American Samoa Power Authority

ISSUANCE DATE: **August 16, 2024**
RFP NO.: **RFP NO. ASPA24.002 – Construction Pago Pago Water Distribution System Upgrade**
SUBJECT: **Addendum No. 2**

RFP NO. ASPA24.002 - Construction Pago Water Distribution System Upgrade

PROJECT NAME: AC PIPE REPLACEMENT PROJECT	REVISION HISTORY:	NO.	DATE	DETAILS OF REVISION	REVISED BY	SCALE: AS SHOWN
DRAWING TITLE: STANDARD METER - PRV ASSEMBLY DETAILS 1/2		1	06/14/2021	SOAK PIT LOCATION	E.L.	PROJECT #: -
PROJECT LOCATION: AMERICAN SAMOA						SHEET NO. 1 2

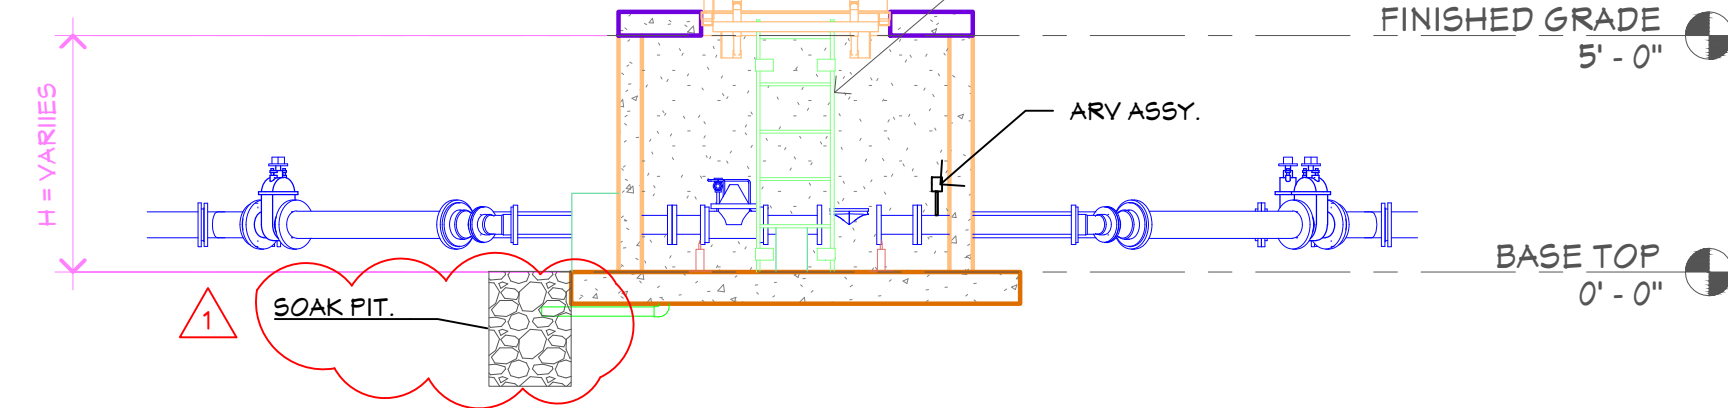
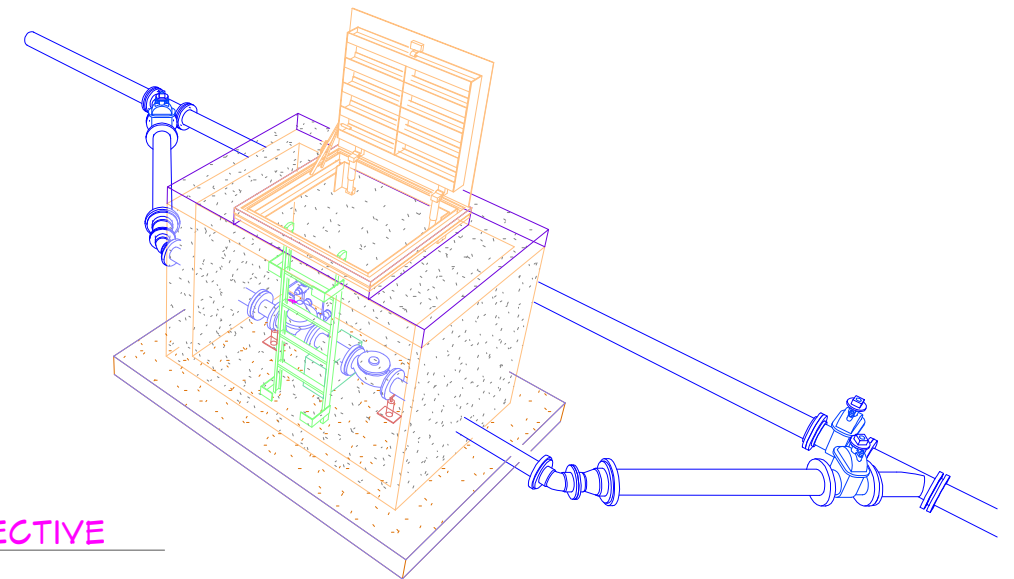
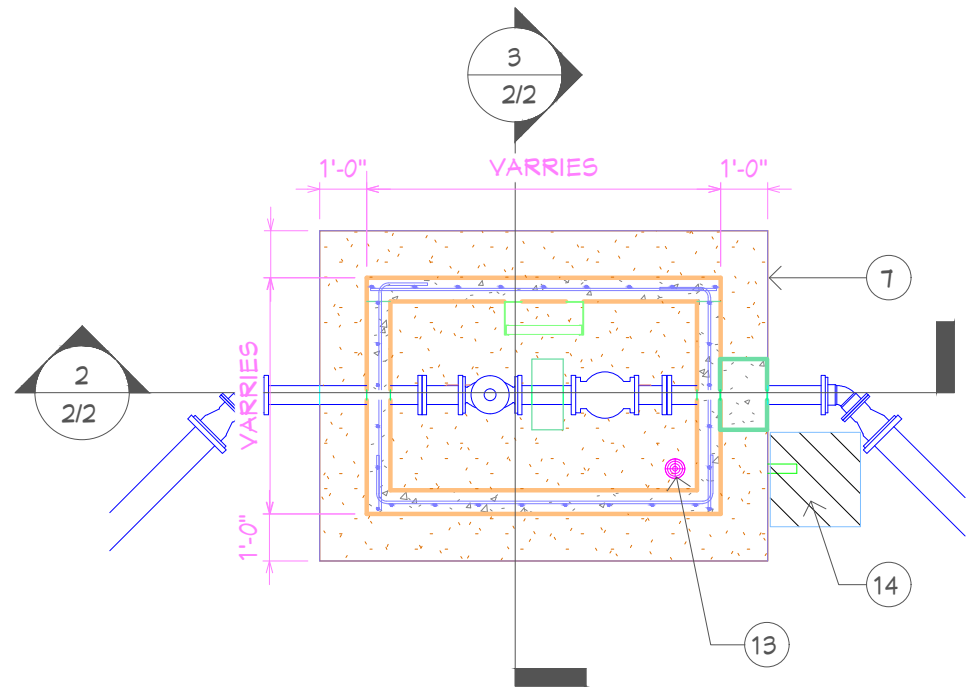
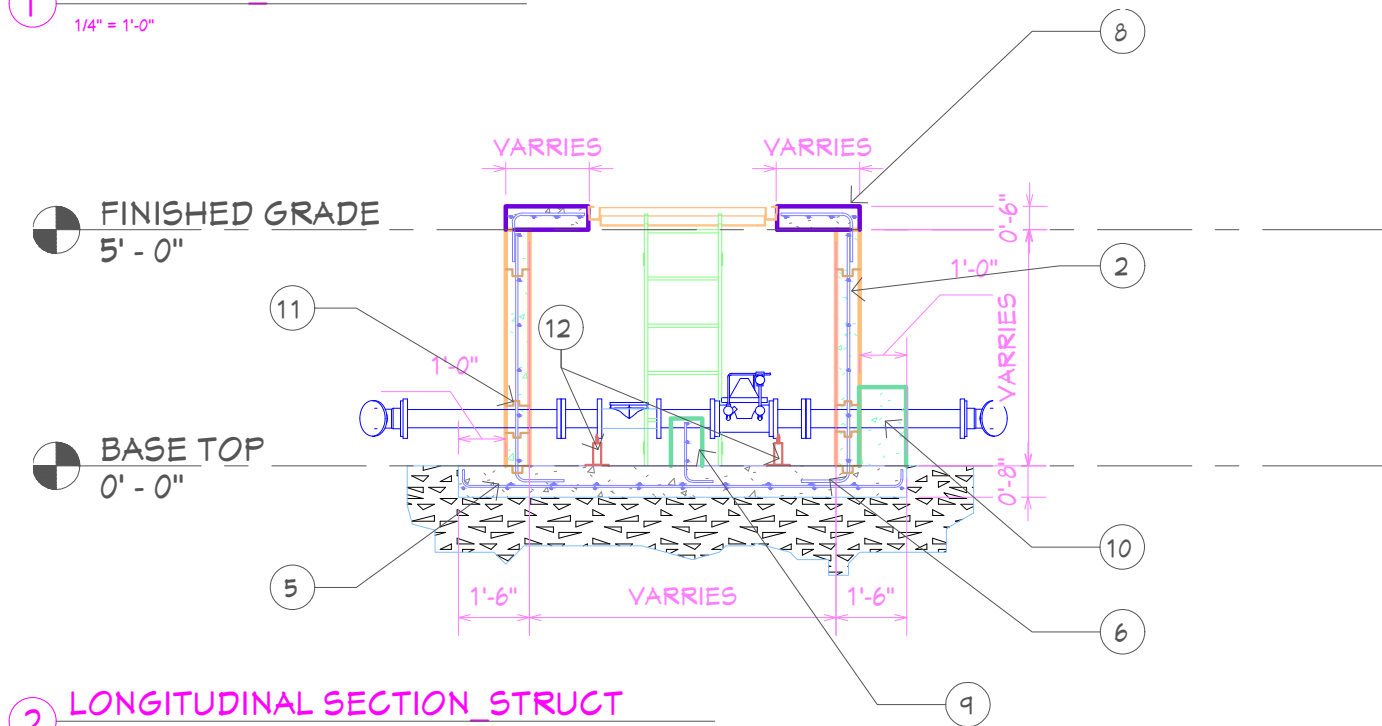
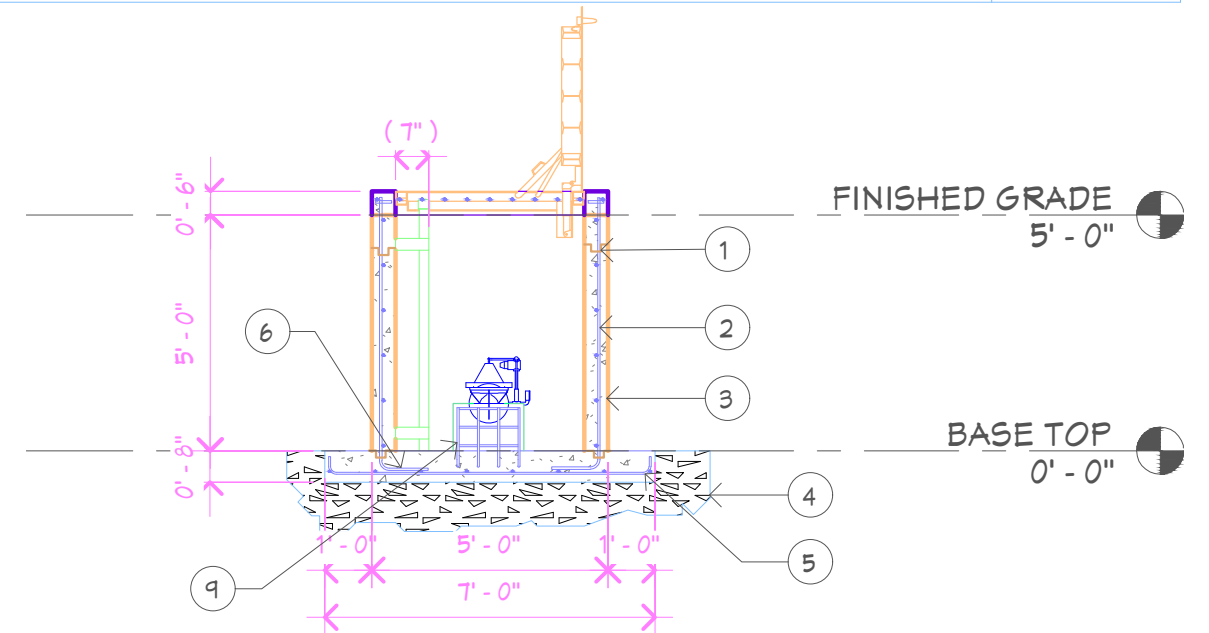
No	Question	Answer:
1	Requesting the PRV detail drawing and location for our reference. In addition, will the PRV cover materials be supplied by ASPA or the contractor?	Refer to attached PRV-Meter Assembly . Currently there is no PRV in the design however, this project is part of 3 projects that will be done simultaneously under separate funding, installing 1ea at a later date is possible. Standard vault cover will be provided by ASPA
2	Are there any separate bid item for "As Built Drawings"?	NO
3	Is there any separate bid item for stripping works and raised pavement markers?	NO, must be included in Road restoration items
4	Can you specify on the plan the ASTCA underground cable alignment?	This work is covered under Potholing bid item no. 3 (refer to SOW section 3)
5	We would like to request for a project duration of 180CD? It is because the total pipeline length of the project is 8,260 lf including main and service lines.	Contractor is required to justify this request by submitting a detailed project schedule or program of works. This submission should include a comprehensive breakdown of activities, timelines, and resource allocations necessary to complete the project within the proposed timeframe.
